# **Appendix C to SRPBS.23.042**

# 10176-78 YONGE STREET EXIST. 2-STORY BLDG RENOVATION

**REVIEWED**  
By: DAL Date: 4/18/2023  
Building Permit #: 2023-00212  
All construction shall comply with the Ontario Building Code and all other applicable statutory regulations. The reviewed documents must be kept on site at all times.  
This review does not exempt the owner, designer and the builder from complying with all applicable regulations and by-laws of the City of Richmond Hill and the Ontario Building Code.  
All construction shall comply with the Ontario Building Code and all other applicable statutory regulations. The reviewed documents must be kept on site at all times.

Reviewed only for the proposed renovation to the facade of the building and renovation to the residential units on the second floor

**1 PROPOSED SECOND FLOOR PLAN**  
1.75

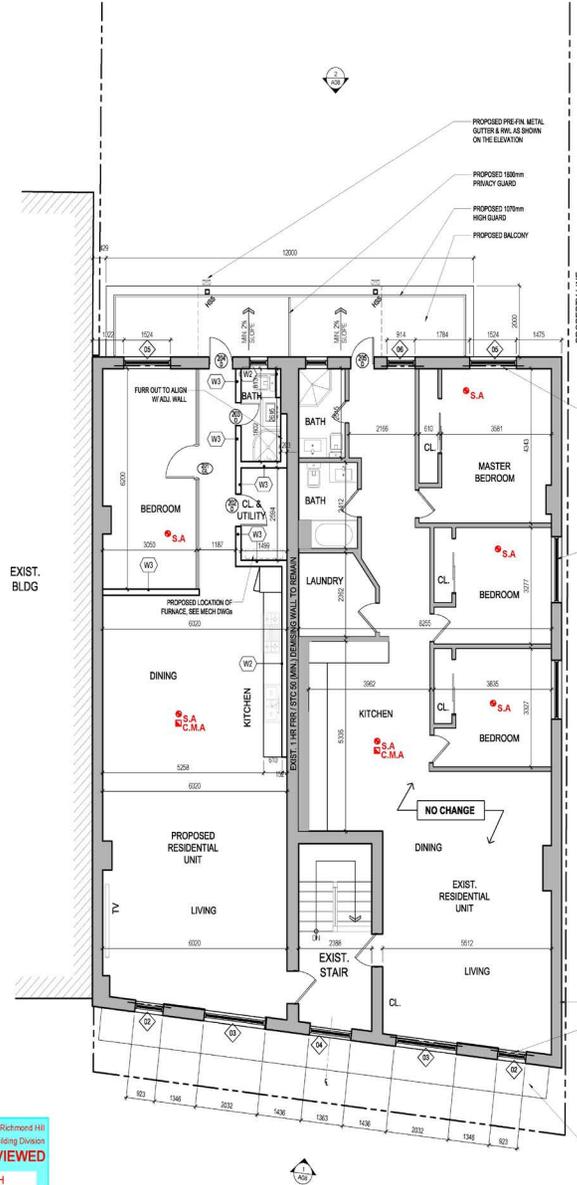
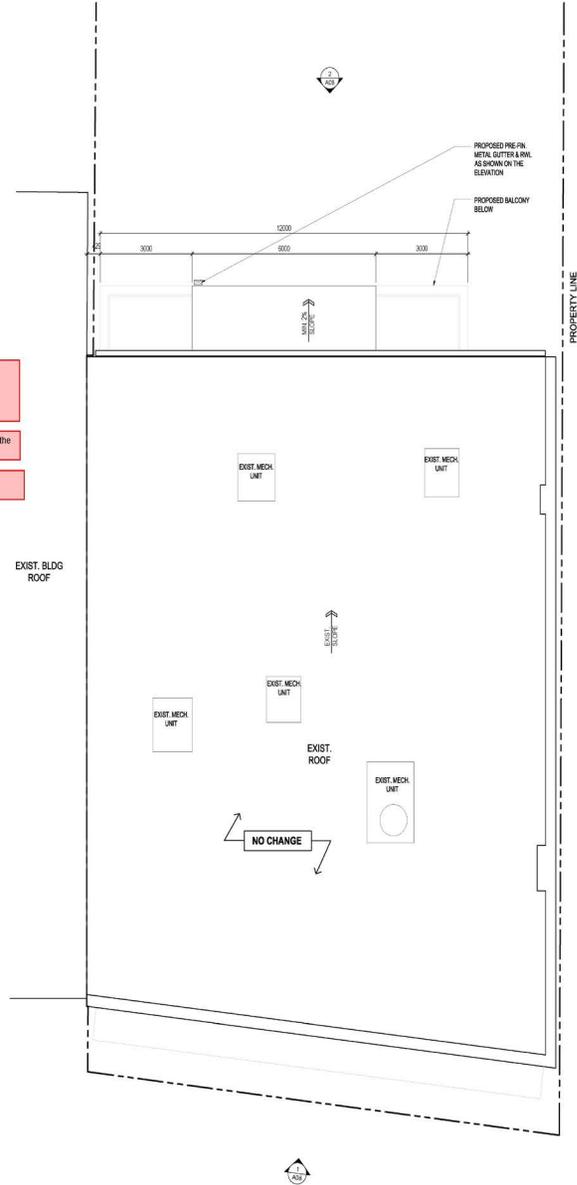
Guards to meet the requirements of OBC 2012 SB-7. Submit CCMC Documents and P.Eng stamped Shop Drawings for approval prior to installation if elements of the guards system contains non P.T Wood material.

Guards to meeting the requirements of SB-7 of the O.B.C.

The integrity of existing fire separation shall be maintained.

**1 PROPOSED EAST ELEVATION**  
1/75

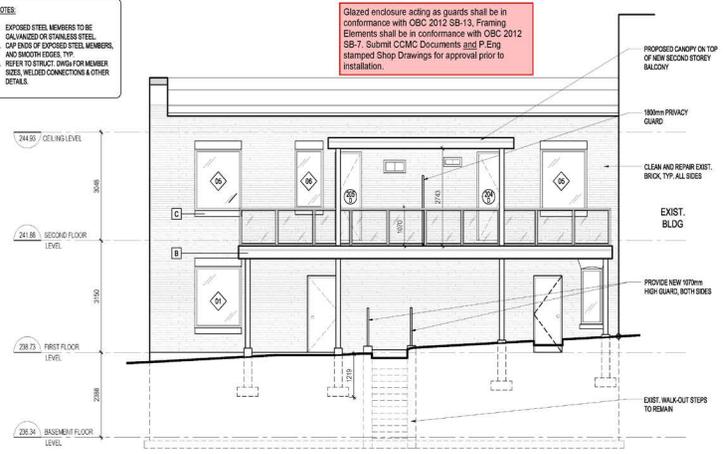
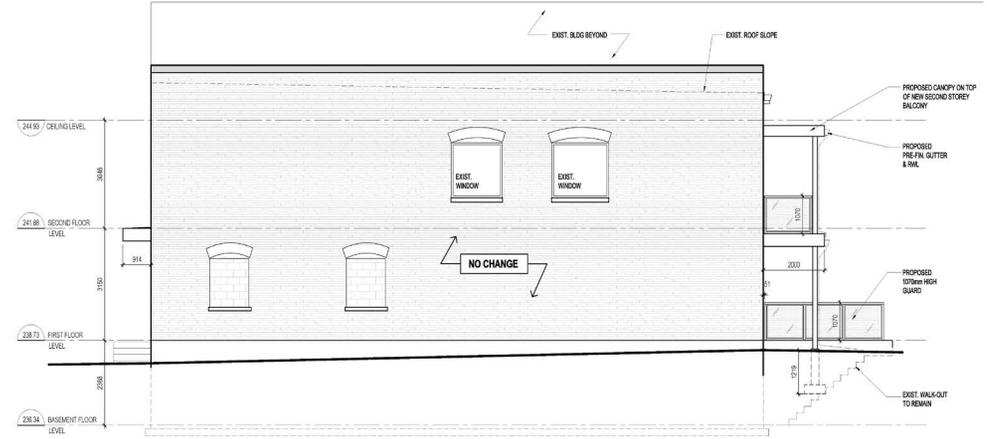
Separate permit is required for the installation of sign

Glazed enclosure acting as guards shall be in conformance with CBC 2012 SB-13, Framing Elements shall be in conformance with CBC 2012 SB-7. Submit CCMC Documents and P.Eng stamped Shop Drawings for approval prior to installation.
